REV.	DATE	DCN #	DRAWING TREE #
A	23MAR05	E050063-00-K	E0500062-A-K

CHECKED C.Torrie 30SEP04			PART NAME Upper-Lower Central Block	
APPROVED			SIZE DWG. NO. B D040389	
SCALE: 1:1			PROJECTION:  SHEET 1 OF 1

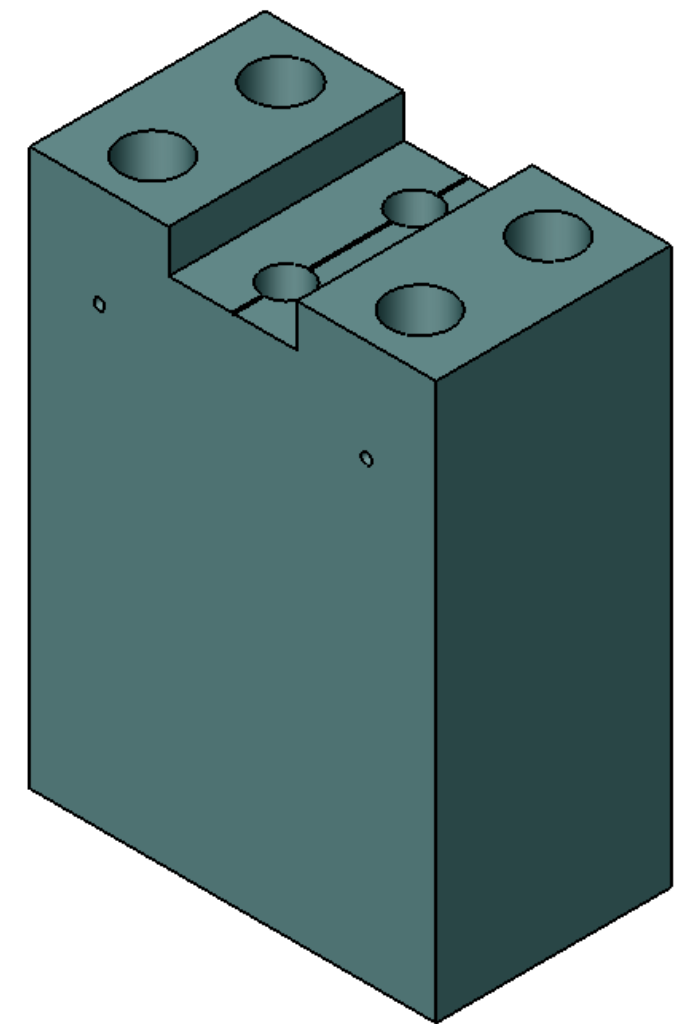
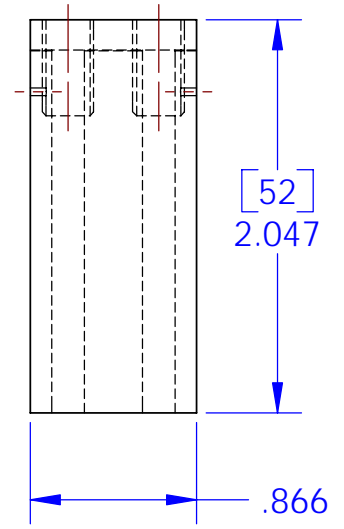
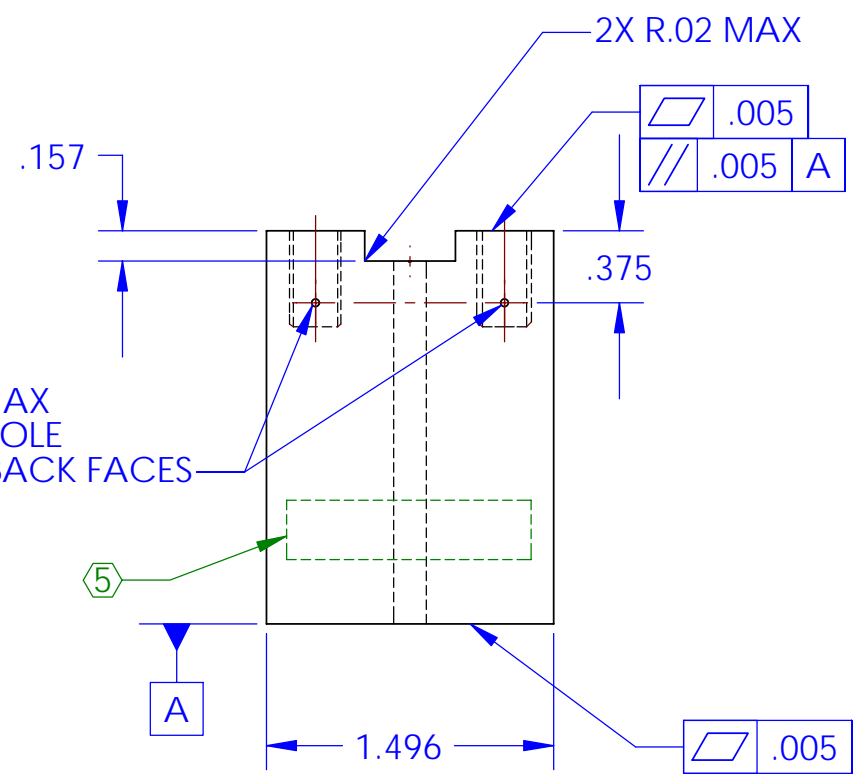
ADD VENT GROOVES  
.02 WIDE BY .02 DEEP

2X VENT HOLES Ø.04 MAX  
THRU TO TRANSVERSE HOLE  
ON BOTH FRONT AND BACK FACES
